GIB SYLVANIA

STEREO HI-FI

SUPPLEMENT 4 TO BULLETIN: R75-3

This supplement lists all code changes to date on the R75-3,-4 chassis.

- SCHEMATIC DIAGRAM (R75-4 AMP) -----

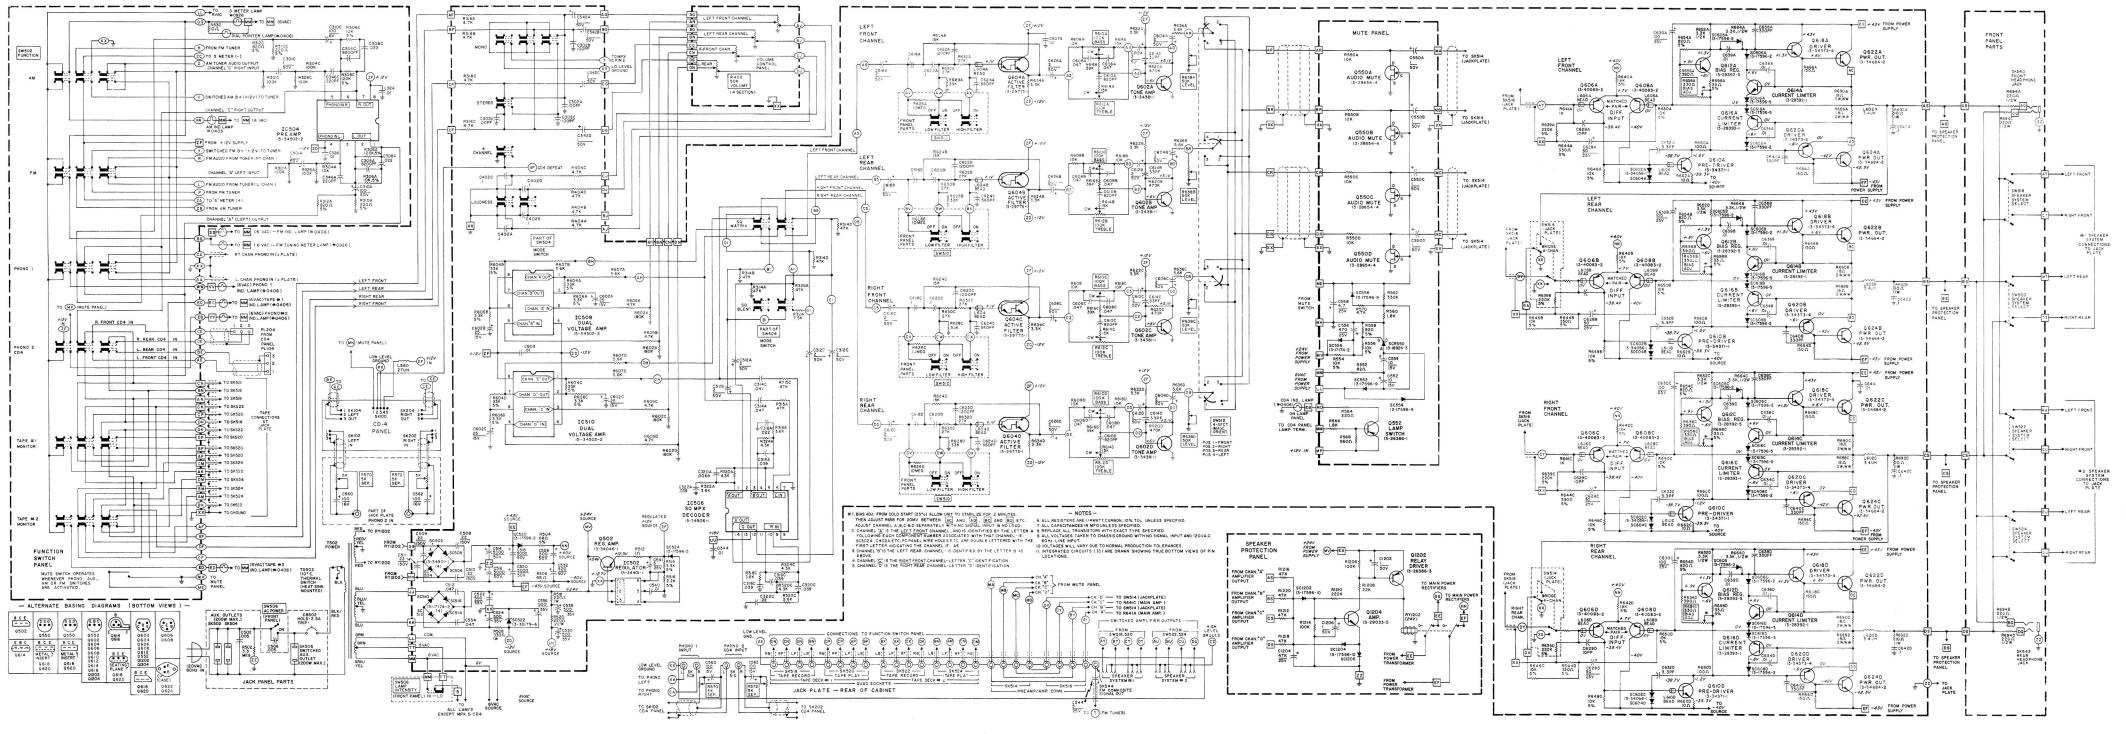
CODE	CHASSIS	PANEL CODE	DESCRIPTION OF CHANGE
03	-4	В	POWER AMP. NOISE PICKED UP IN AM MODE.
			 C1 14 value changed to .05, 50 V. C529 (.22, 150 V) added from amplifier end of +32 V buss to ground on foil side of P/C panel. C629 (10pF, NPO) added between Base and Collector of Q606. NOTE: All chassis (regardless of code number) having RED, YELLOW, GREEN, BLUE or any ONE of these stripes, prior code 03, will be the SAME AS THE CODE 03 CHASSIS.
04	-3		RF PICK-UP IN PHONO PREAMP.
4		,	 C304 removed. C346A (1000pF, Z5P) added between pins No. 2 & 3 of IC504. C346C (1000pF, Z5P) added between pins No. 5 & 6 of IC504.
			TO ELIMINATE POP WHEN SWITCHING FROM FM TO AM. 1) C46 removed. 2) R302A, C removed. 3) R326A, C value changed to 100K. 4) R63 (100K, 5%) added from wire hole L1 to ground. 5) R65 (100K, 5%) added from wire hole R1 to ground. 6) R149 (100K, 5%) added from square wire pin Z to ground. 7) R301A (100K, 5%) added from + end of C301A to ground. 8) R301C (100K, 5%) added from + end of C301C to ground.

TO ELIMINATE POP WHEN SWITCHING FROM FM TO PHONO. 1) C72 value changed to 1MFD/50V.
			2) C74 value changed to 1MFD/50V. TO FACILITATE BOARD ASSEMBLY.
		,	 C108 (10MFD/15V Electrolytic) added from junction of R112, R114 to ground. Q604 part number changed to 13-29775-1.
			TO REDUCE SWITCH POP.
			 C604 value changed to 2MFD/50V. R314 value changed to 47K, 5%. R607 value changed to 5.6K, 5%. R620 value changed to 470K. R634 value changed to 3.3K, 5%.
04	-4	В	FET RELIABILITY IMPROVEMENT.

1) Q2 part number changed to 13-34378-3.
